Our Reference: 212600

**RE: SSD-32722834 113-153 Aldington Road, Kemps Creek**

## Attachment 1 – Detailed stormwater requirements

This review is for the Dexus State Significant Development Application (SSDA) (SSD-32722834) at 113-153 Aldington Road, Kemps Creek.

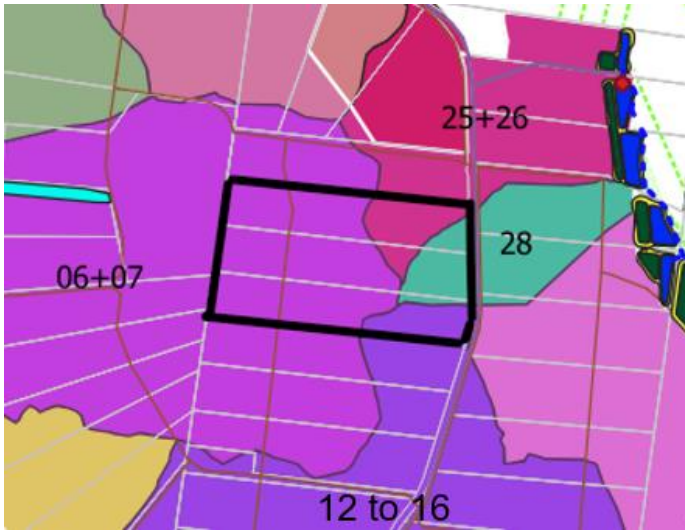
The natural catchment plan has 6 discharge points (catchments A to F), which drain to 4 regional basins. The proposed changes to the catchments allow for 4 discharge points, which drain to 3 regional basins. All except for discharge point 1 (which includes natural catchment A and C) exceed changes in natural by + /– 10%.

The regional scheme has been designed to accommodate existing catchment areas (unless otherwise altered by the Stormwater Management Authority (Sydney Water)). Changes from the design catchments alter the performance of the downstream basins and may require additional OSD requirements to ensure downstream trunk drainage capacity is adequate.

The impact of the proposed change on the downstream basins has been evaluated as unacceptably large and the proponent is required to alter catchments to match more closely with existing catchments in this area. See our analysis of the catchments (natural vs proposed) in the table below. If further clarification is required and there is need to discuss the proposed solution please organise a meeting with Sydney Water.

Below is the image from the GIS system to show the regional basin catchments.

Figure 12 Net developable area within the site once constraints are accounted

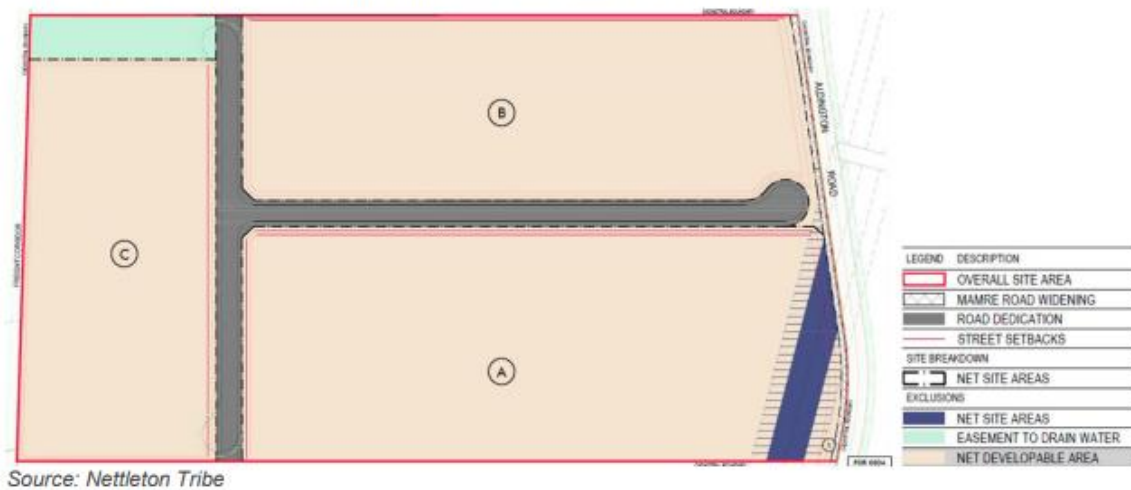
1. Provide street tree planting detail. No street tree detail has been provided in Civil or Landscape package.
2. The EIS indicates that there are 50 cartridge filters for the interim stormwater quality treatment, but the water and stormwater management plan only indicates 20. Please confirm which one is correct and ensure documentation is consistent.
3. There is an image that shows the drainage line in the north-west corner as part of an easement (see below). Note this will not be a Sydney Water asset as it not on the scheme plan as trunk drainage channel. Is this channel to remain in private ownership and management? If yes, it should be documented in the operation and maintenance plan for the stormwater assets that should include the GPT's and OSD systems.

Figure 54 North western corner drainage flow channel section

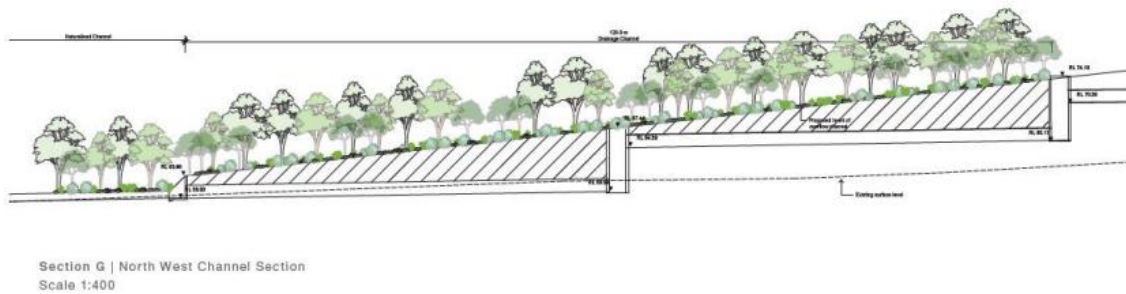
4. Sydney Water is concerned regarding the design of the steep (11%) overland flow path channel in the north-west corner. As this channel drains into a trunk drainage channel managed by Sydney Water it will need to be designed appropriately and have appropriate operation and maintenance to reduce risk of sedimentation of the downstream channel. More detail will be required to:
- indicate how the flow velocities within the channel will be controlled to prevent erosion and scour.
  - ensure there is sufficient flow control/dissipation to reduce the flow velocity within the Dexu site before the stormwater enters the downstream trunk drainage channel.
